TRANSMISSION

No.
63/8

SUBJECT: D TYPE OVERDRIVE CHANGE

MODEL: ALPINE II III RAPIER III

POSITION OF GEAR BOX/OVERDRIVE
OIL HOLES
POSITION OF REAR

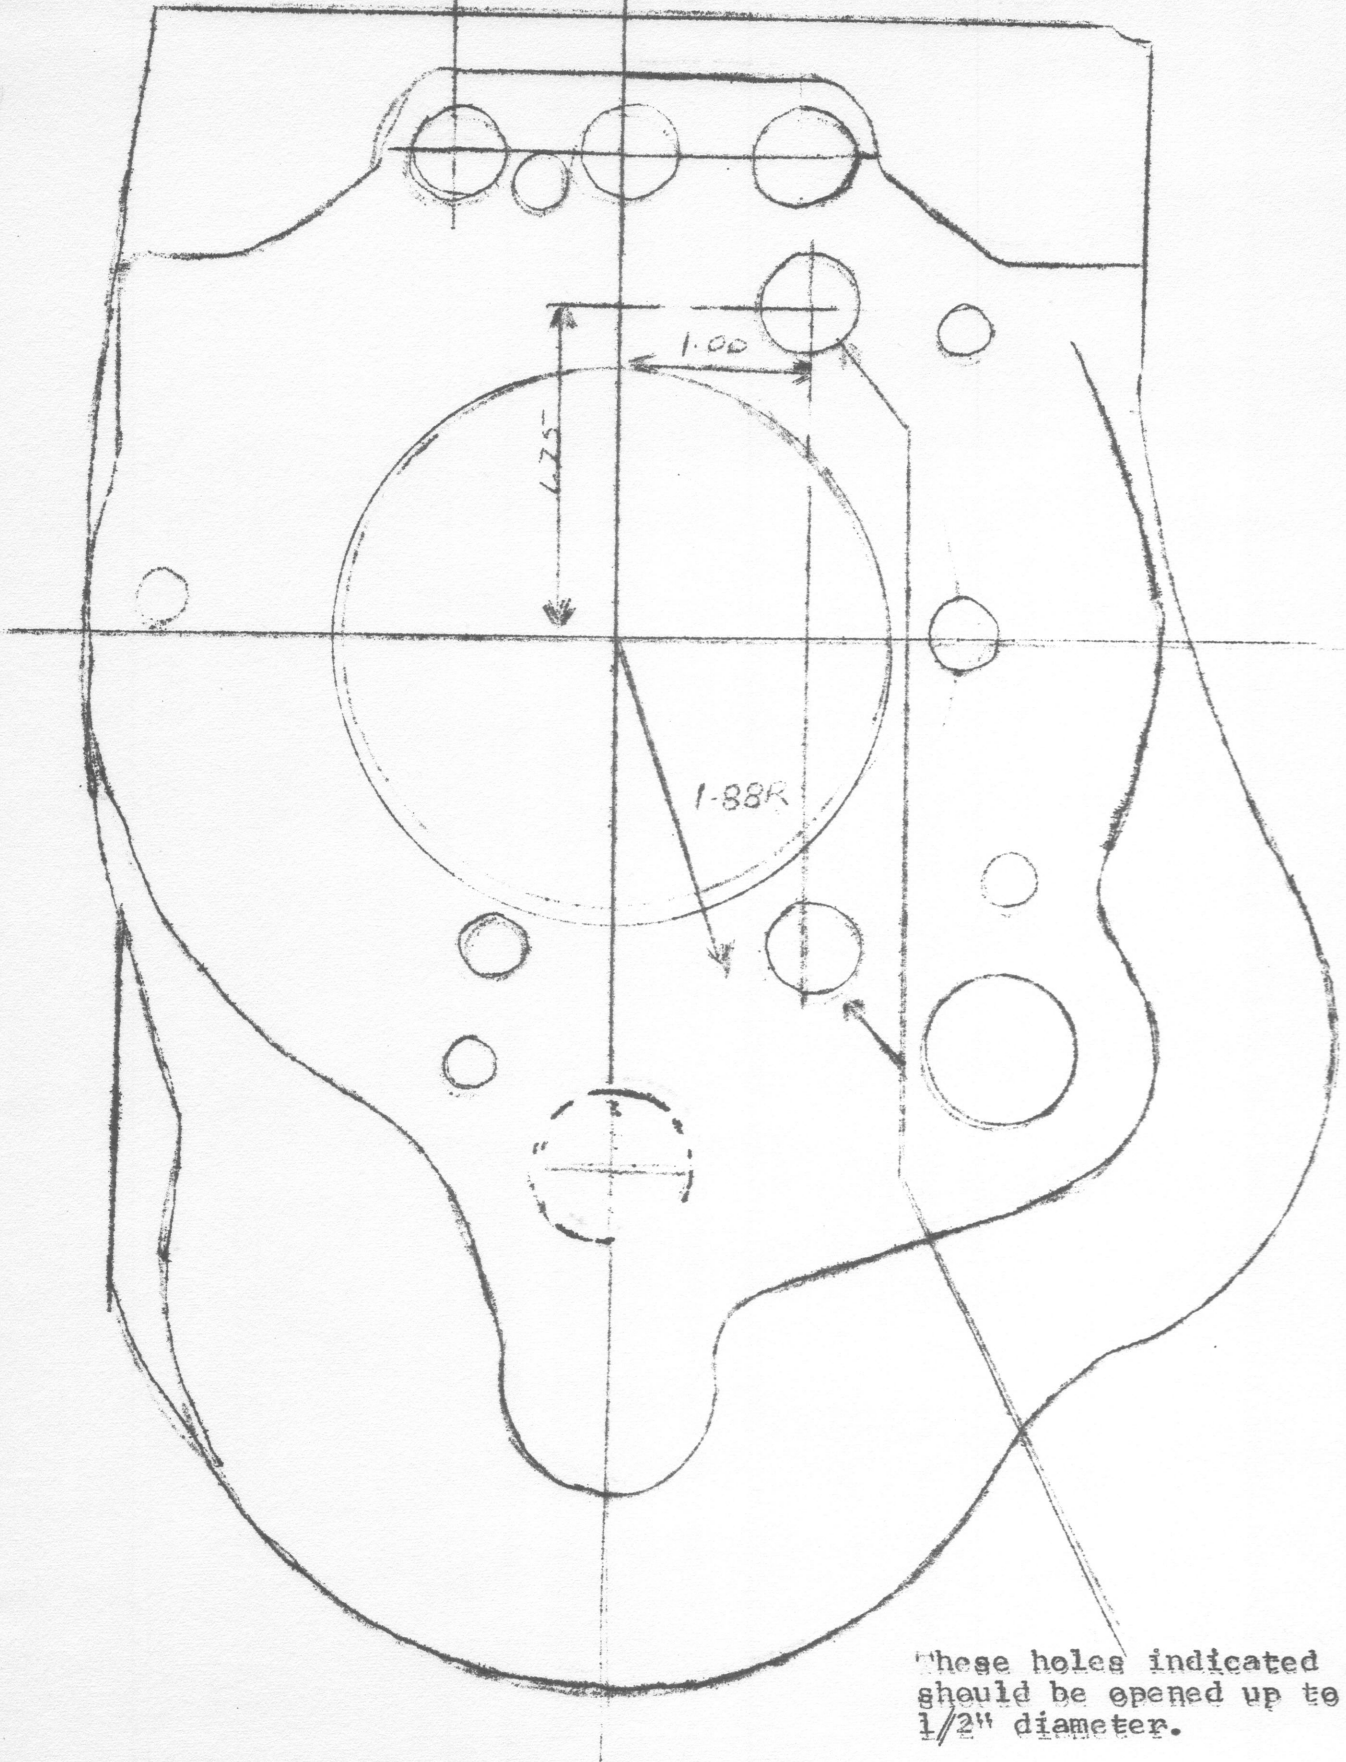
Isolated cases of overdrive oil pressure failure have occurred on cars associated with high speed driving over prolonged periods. Most of these failures have been traced to low transmission oil level and to allow a more positive feed to the overdrive, modifications to both transmission and overdrive became effective from Alpine Serial #9119093 and Rapier #3064241. The modified overdrive for the Rapier is part #1223666 and the Alpine #1218080.

With the overdrive change modifications to the transmission parts enumerated below have been incorporated:

In the event of a new overdrive being fitted to vehicles bearing a chassis number prior to Alpine #9119093 or Rapier #3064241 the unit should be fitted together with the mainshaft, adaptor plate, cam and bolts shown above and the following modification carried out on the transmission case: Open out

These holes indicated
should be opened up to
1/2" diameter.
